STATE OF WASHINGTON
DEPARTMENT OF ECOLOGY

15-NWP-032

Re: Withdrawal of the Proposed September 2014 Permit Modification for the *Hanford Facility Resource Conservation and Recovery Act Permit, Dangerous Waste Portion, Revision 8C, for the Treatment, Storage, and Disposal of Dangerous Waste*, Part III, Operating Unit Group 10, Waste Treatment and Immobilization Plant, WA7890008967

Response to Comments

SEE SHEET #3 FOR BILL OF MATERIALS

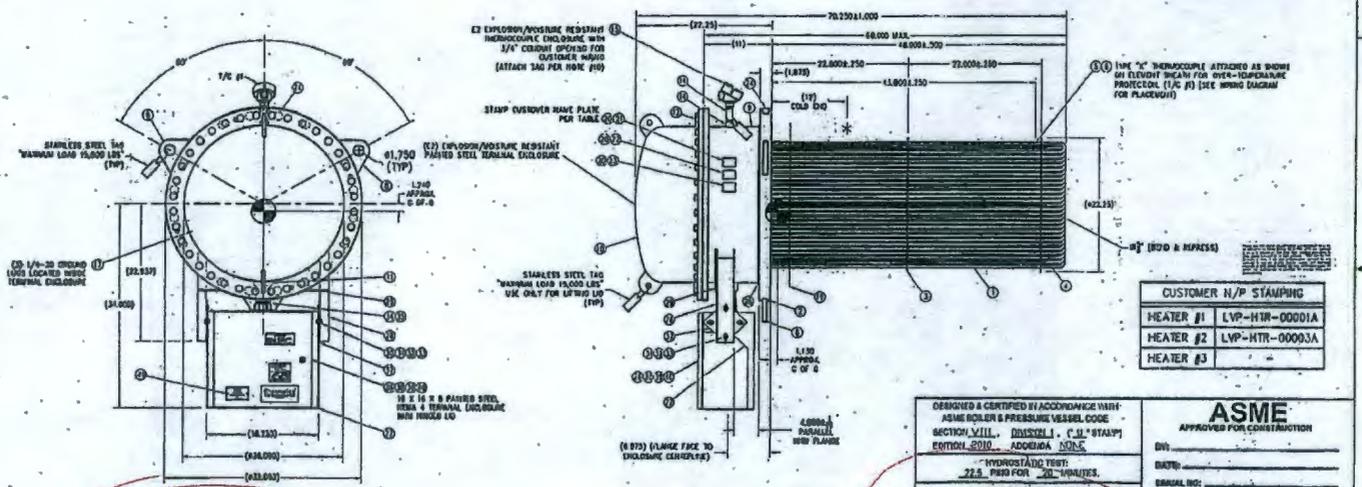
In spite of this the vendor drawings (24590-CD-POA-MEE0-00003-03-0004, Rev 00H and 24590-CD-POA-MEE0-00003-03-0005, Rev 00I) both show in the Design Data Box that the process gas is "air" (not process gas) and each has a check box that is clearly marked that there are no "lethal substances." Contrary to the check boxes, NIOSH has established that the "immediately dangerous to life and health" (IDLH) concentration for NO₂ is 20 ppm_v and the IDLH for NO is 100 ppm_v. The incoming gas to the heaters is therefore more than 285 times the lethal concentration. The vendor did not seem to be aware of this when selecting their equipment. As a result, it may not be fit for hazardous chemical service. The vendor did not list the acid gases or chloride present in the corrosion evaluation either. The NIOSH web page is <http://www.cdc.gov/niosh/idlh/intrid14.html>.

- The Corrosion Evaluation noted on page 1 that type 304-L and Carbon Steel are unacceptable materials. The Mechanical Systems Data sheet indicates this is a Quality Level "Q" procurement. The two vendor drawings provided to Ecology, however, each

only included the first of three sheets. The first sheet notes that the “bill of materials” is located on Sheet #3, which was not part of the package submitted to Ecology. So it is impossible verify if appropriate materials were used or if commercial grade materials were qualified for a “Q” application. Resistance of small parts to the oxidizing environment of the NOx appears to have been ignored, at least in the mechanical systems data sheet. This leaves the construction of the heaters open to question.

Your comment details your concerns related to the Corrosion Evaluation and the Mechanical Data Sheet included in the package. Ecology reviewed the technical and quality control issues documented in your letter. We also discussed these issues with DOE-Office of River Protection (ORP) and Bechtel National Inc. (BNI).

BNI had previously committed to providing to Ecology a revised Process Corrosion Data Sheet (PCDS) with the Corrosion Evaluation submitted with this package. However, Ecology found that the Corrosion Evaluation did not include the latest version of the PCDS. BNI has informed us that the Corrosion Evaluation is being updated with new calculations and will be presented in a new format.

We recognize that the original package submitted was incomplete. We will make sure all the technical concerns are addressed and resolved with the permittees before re-issuing the LAW-026A package for public review.
